御中										Issue No. / 発行№ : PC-0029850												
										Issue date / 発行日 : 2023/2/7												
<h2 style="text-align: center;">工程変更連絡書</h2> <h3 style="text-align: center;">Process Change Notice</h3>										ヒロセ電機株式会社 郡山工場 品質管理課 Koriyama Factory, Quality control section, Hirose Electric Co., Ltd.												
										承認 (Approval)			査閲 (Review)			作成 (Created by)						
										塚本 Tsukamoto			稲垣 Inagaki			野内 Nouchi						
貴社益々ご清栄のこととお喜び申し上げます。日頃は弊社製品のお引き立てを賜り、厚く御礼申し上げます。 早速ですが、貴社への納入製品について、下記の通り工程変更を計画しております。 本書にて工程変更のご案内をさせていただきます。変更計画可否を提出後 2週間以内に返却を賜りたくお願い致します。 We truly appreciate your significant support always. We are currently planning on the below process change for the products planned to be delivered to your company. Forwarding shares the notification of the process change. Your approval for the change plan within 2 weeks will be appreciated.																						
貴社品番/Customer's product number										弊社品番/Product number by Hirose					弊社品名/Product name by Hirose

680-1016-3 05 (See attachment 1)					DF22-4P-7.92DSA(05) (See attachment 1)							
Content of change / 変更内容	Change 1		区分 Type		Assembly method change					理由 Reason		To improve productivity										
	Cha

Lot marking font

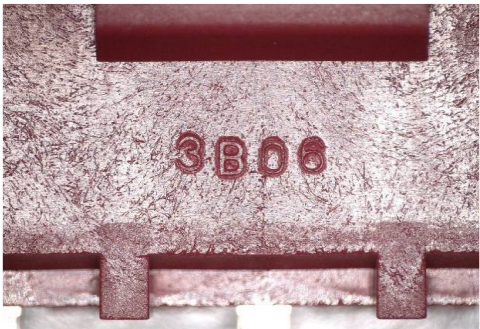
Existing product via. hand assembly

After-change product via. automatic assembly machine
